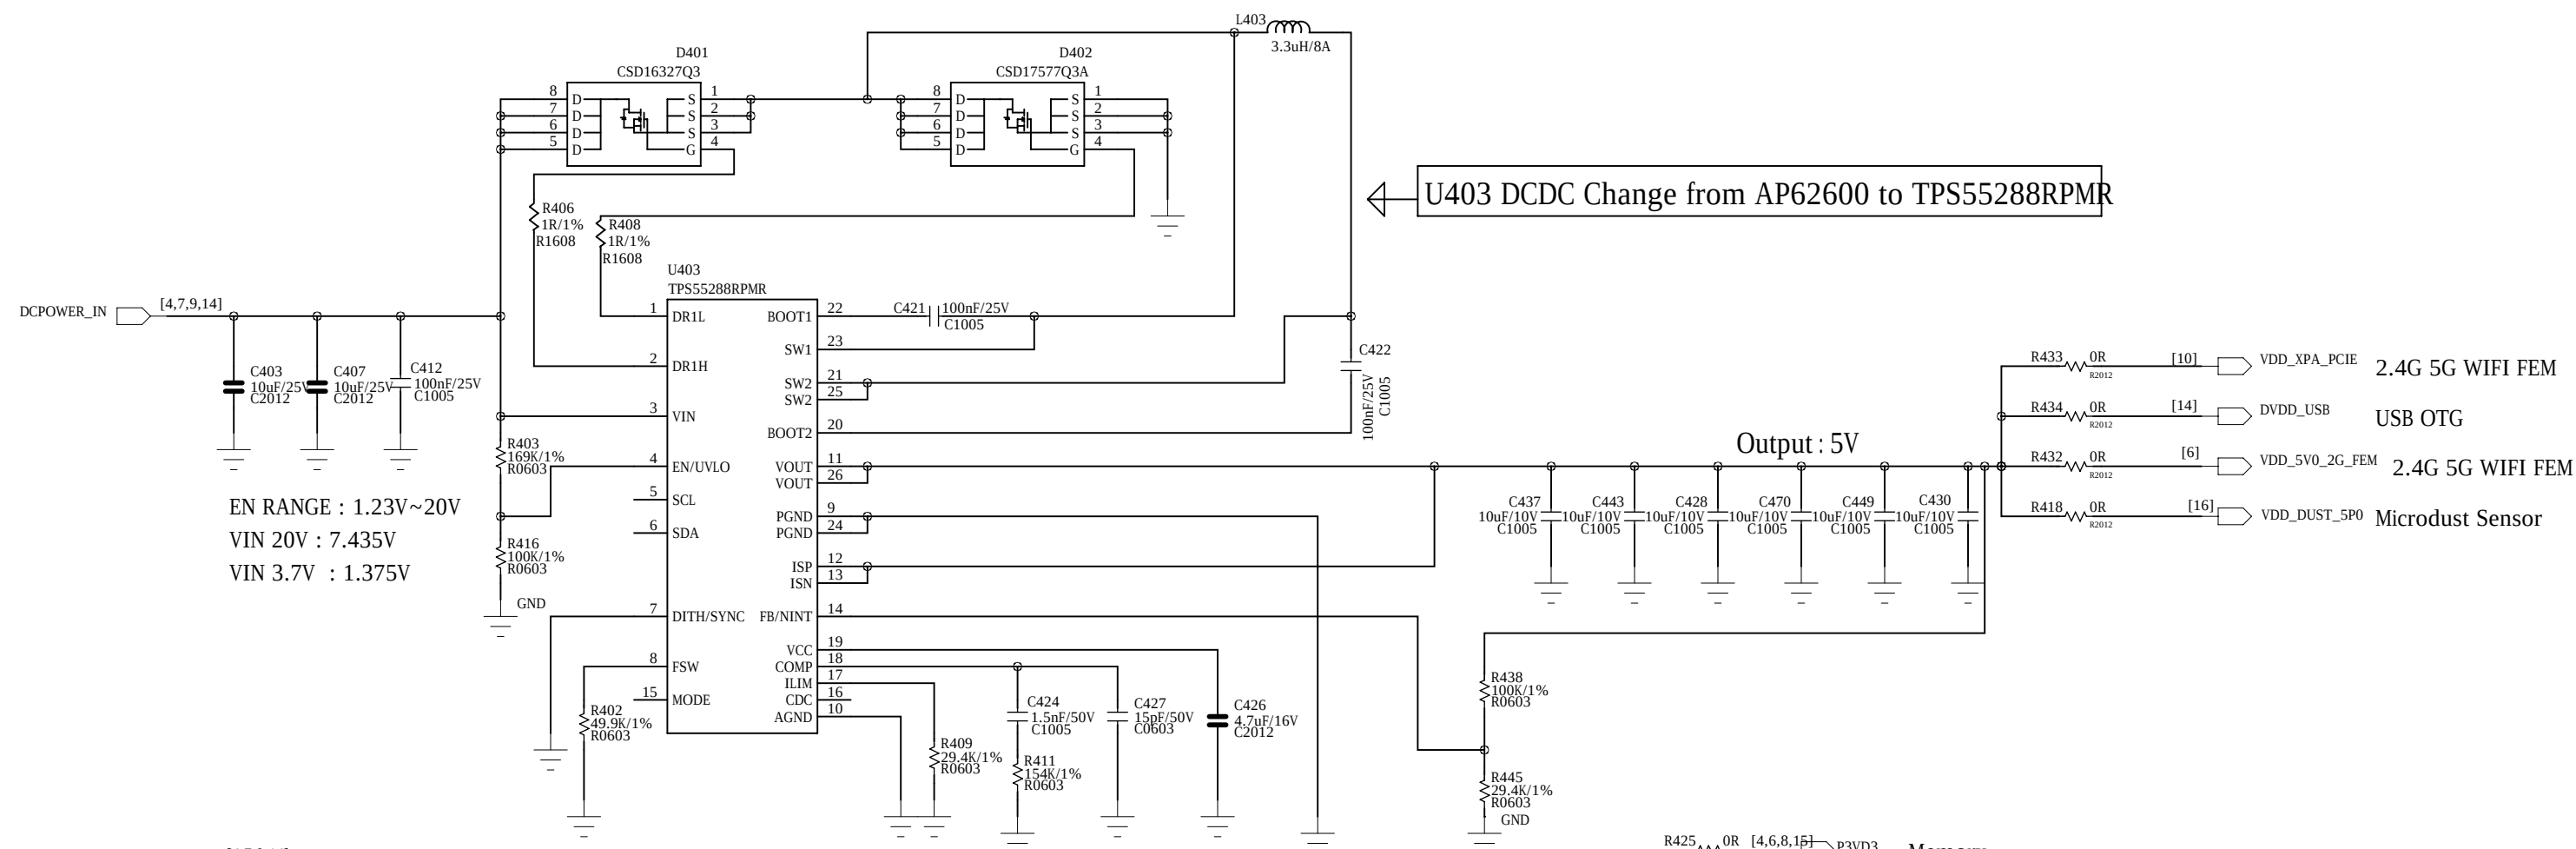
U404, U406, U401 DCDC Change from AP62600 to TPS566242DRLR

U402, U405 DCDC Change from AP62300 to TPS563231DRLR
